GULF STATES UTILITIES COMPANY

March 29, 1984

River Bend Station - Unit 1
Docket No. 50-458

13.1 ORGANIZATIONAL STRUCTURE OF APPLICANT

FIGURE 13.1-2

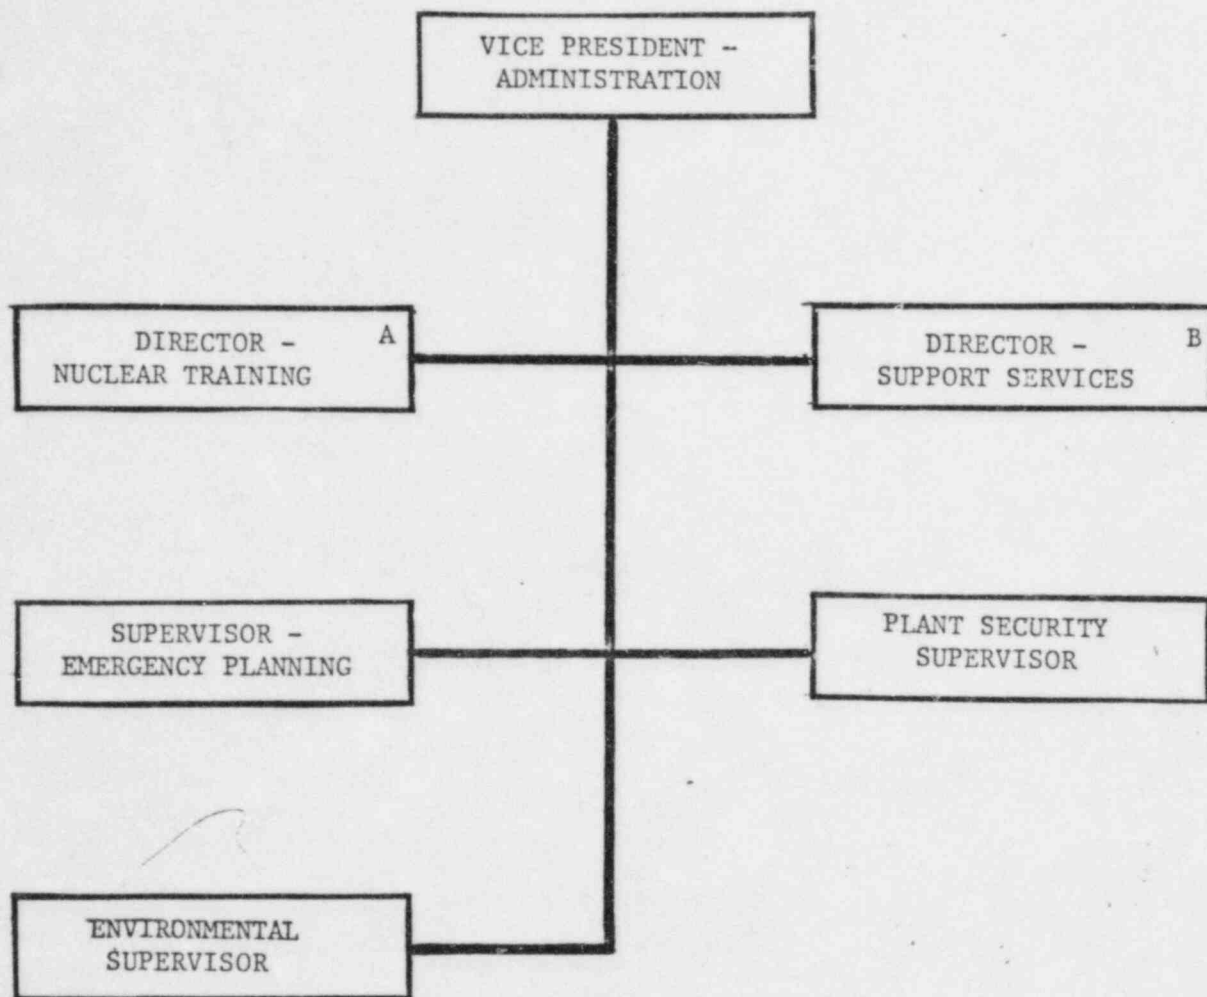
ADMINISTRATIVE
PLANT ~~OPERATIONS~~ STRUCTURE
RIVER BEND STATION — UNIT 1
